विषय :- कुनिगाड़-हिरुली बाजार से रामपुर चौखुटिया मोटर मार्ग के निर्माण(प्रस्ताव संख्या 8986/2014)
संदर्भ :- आपकी आपत्ति दिनांक 8.06.2016.

विषय कुनिगाड़-हिरुली बाजार से रामपुर चौखुटिया मोटर मार्ग के निर्माण(प्रस्ताव संख्या 8986/2014)
सन्दर्भ- आर्न लाईन आपत्ति

विषय :- कुनीगाड हिरुली बाजार से रामपुर चौखुटिया मोटर मार्ग के वन भूमि हस्तान्तरण के सम्बन्ध में। (प्रस्ताव सं. 8986/2014)

कार्य का नाम :- कुनीगाड हिरुली बाजार मोटर मार्ग का रामपुर चौखुटिया तक विस्तार मोटर मार्ग का निर्माण

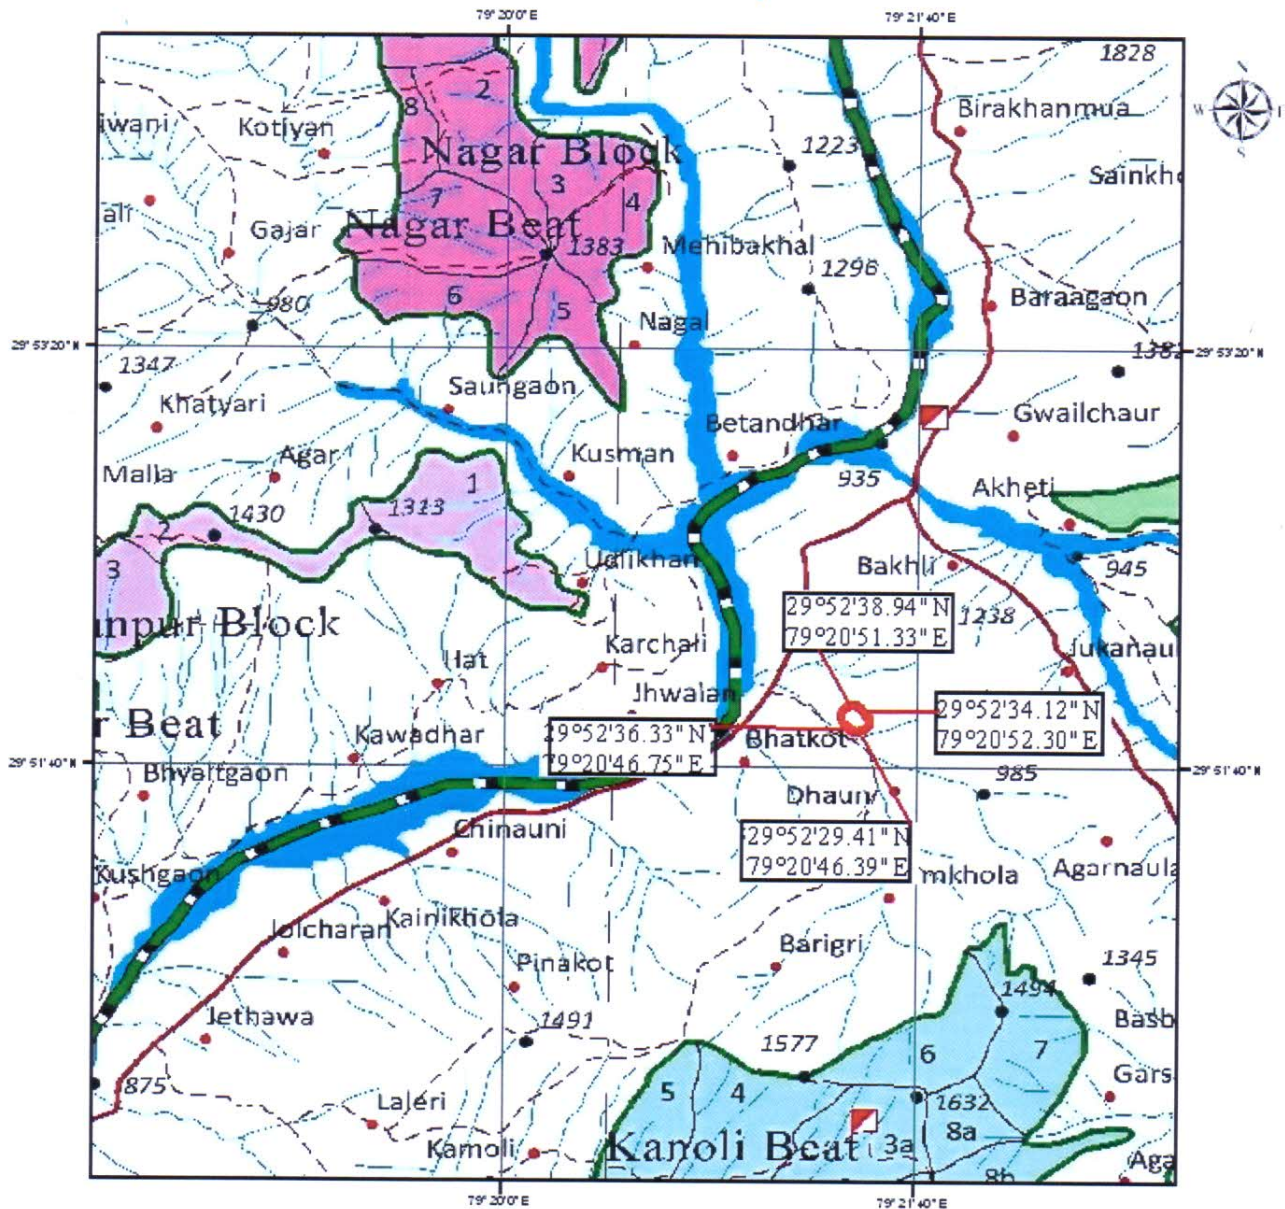
1	Digital map not proper as coordinates are written in hand. Proper digital map may provided.	Proper digital map with computerized coordinates is being attached .
2	In the map end point is shown for away from Rampur.	.The Rampur Village is on the right side of the National Highway (shown as red colour) in the digital map. The portion of the road from the end point of the proposed road upto the National Highway near Rampur has already been constructed which is shown as black colour in digital map. The revised digital map is being attached as in point no.-1
3	No titles given to thee document provided in the list of additional documents in part I.	Titles given to the documents has been incorporated in the list of additional documents in part-1
4	Forest land proposed for diversion shown as Van panchayat land in joint inspection report whereas shown PF in part II	
5	In Ca land map coordinates are provided for one point only whereas CA land being more than 1 ha coordinates at minimum 4 points are required.	Digital map for C.A. consisting coordinates of 4 points is being attached.
